From: Wooldridge, John
Sent: Tuesday, June 9, 2020 7:45 AM
To: Chris E. Howard; James Howard
Cc: Heim, Kimber; Norton, Harvey
Subject: RE: 110412 FAI 037 Safety Project D5 Requests Cost Proposal ASAP

Subject: RE: FAI-37-6.34 Preliminary Right of Way Plans (PID No. 110412)

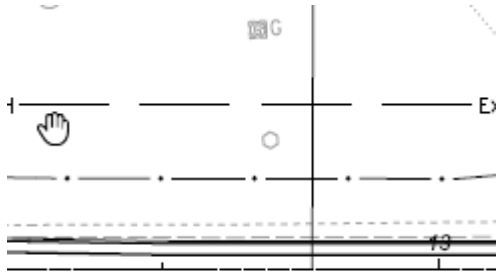
I looked over these plans and have only a few comments as they were pretty good for R/W. The Stage 1 comments and our meeting with them was obviously beneficial to the quality of this submission. Thanks Doug.

- Missing sheet 20 of 37 as Luke stated.
- Page 21/36 (22/37) Parcel 11-SH shows "Utility Pole Save" for private light poles. I would have them removed as ODOT will need to pay for them anyways (in take area) and would need to do a permit (not recommended) for the poles that are very close to the fence needing removed. Same Parcel has three of those poles (not 2) and also has a small sign near the fence that was not picked up on these plans:

- Page 23/36 (24/37) Can Parcel 12-SH be completely removed? The Construction limits are almost all out of the take and the ditch is in the Ex R/W. Could save some money having one less parcel.
- Page 25/36 (26/37) 14 no take, Please mark encroachment of a singular post:

- PG 31/36 (32/37) We may have future comments about the water building. Pending Village of Thurston review comments. Latest email by Utilities is attached.
- PG 31/36 (32/37) PCL 9 No Take has encroachments to mark for removal (2 of the 3 signs ... last one shown as "save" not in R/W):

- Several pages: “edge of farm field ... SAVE” within R/W is shown; I do not recommend saving that as it will not be permitted and construction company should be able to use all the R/W existing at their discretion. We typically do not label it either save nor remove.
- Legal descriptions were not provided to me and therefore not reviewed against these R/W Plans.
